# SERVICE BULLETIN REVISION TRANSMITTAL SHEET

MODEL BD-700-1A11 (BD-700)

Service Bulletin No. 700-1A11-31-008  
Date of Basic Issue Aug 29/2006  
Revision No. 01 Dated Dec 14/2009

**MODIFICATION – FLIGHT DATA RECORDING-SYSTEM –  
 INTRODUCTION OF A QUICK ACCESS RECORDER**

**KGC991-0026** – Kit – Quick Access Recorder Wiring Installation  
 (Sheet 1 of 1, Rev. - -)

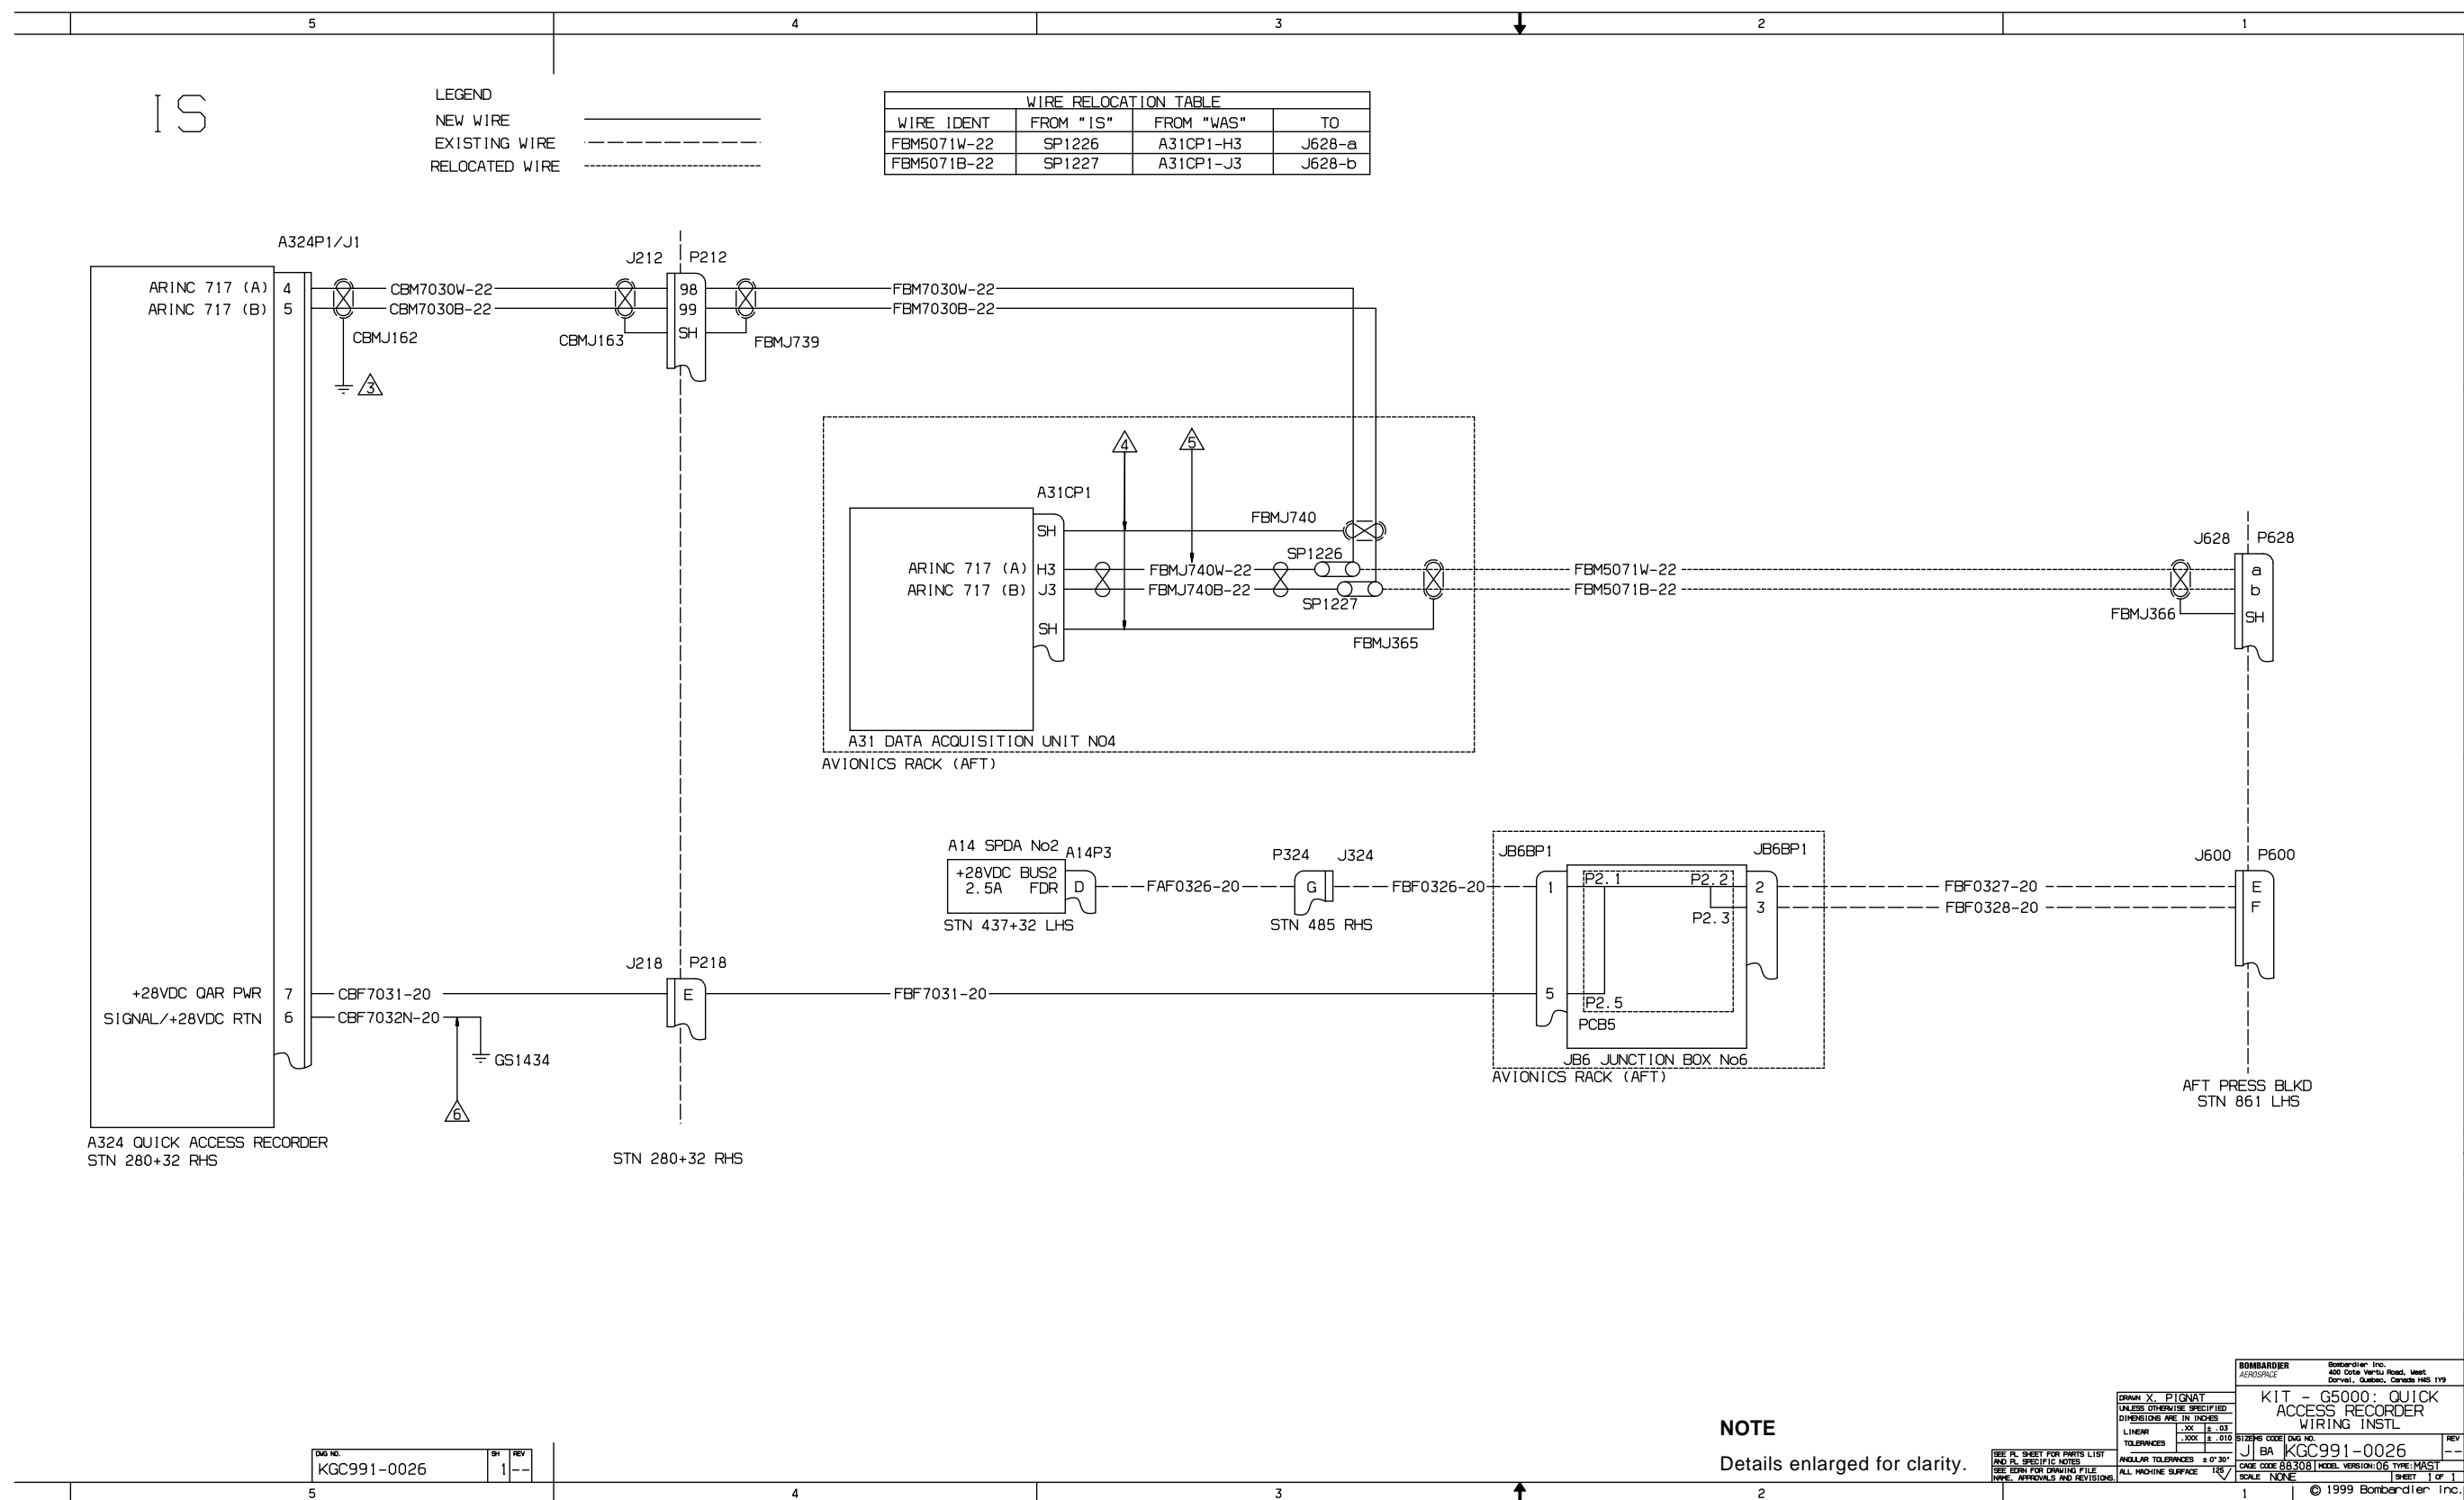
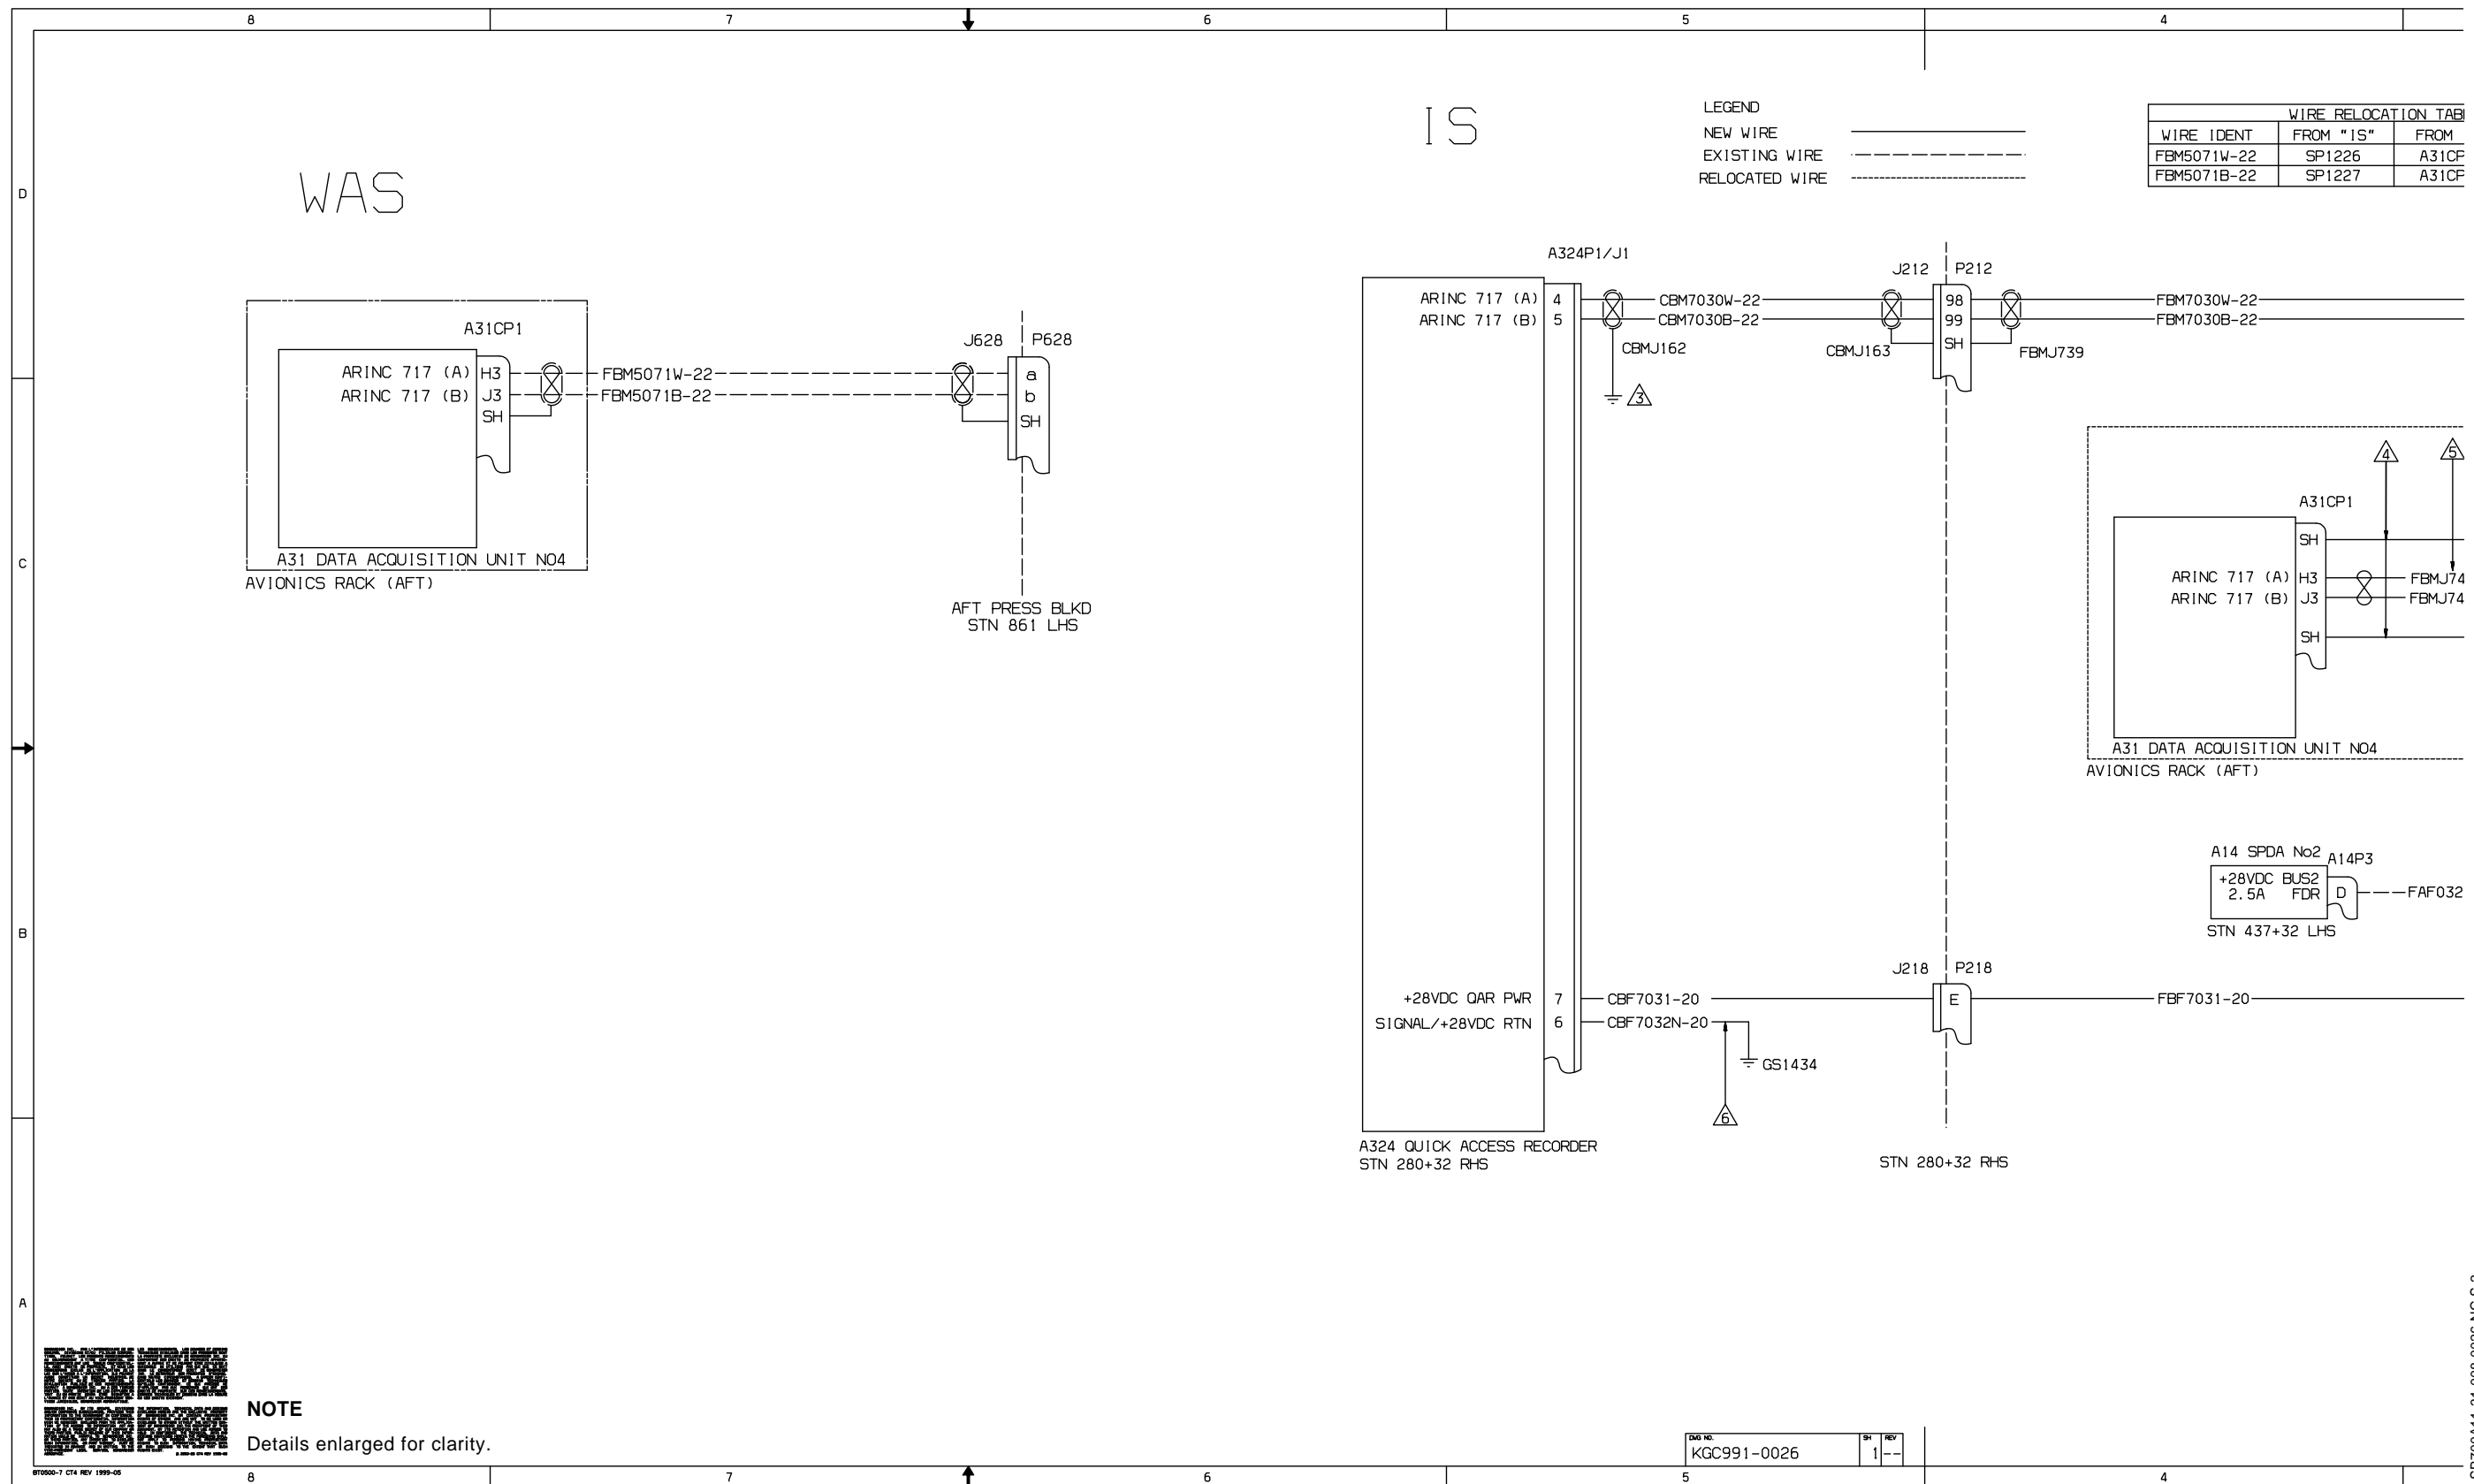
9. Change Paragraph 2.C.(15), to read: "Do the electrical bonding test between the QAR aircraft side connector and the aircraft structure. Refer to TASK 51-80-00-760-801." to incorporate Info Sheet dated Jan 21/2008.
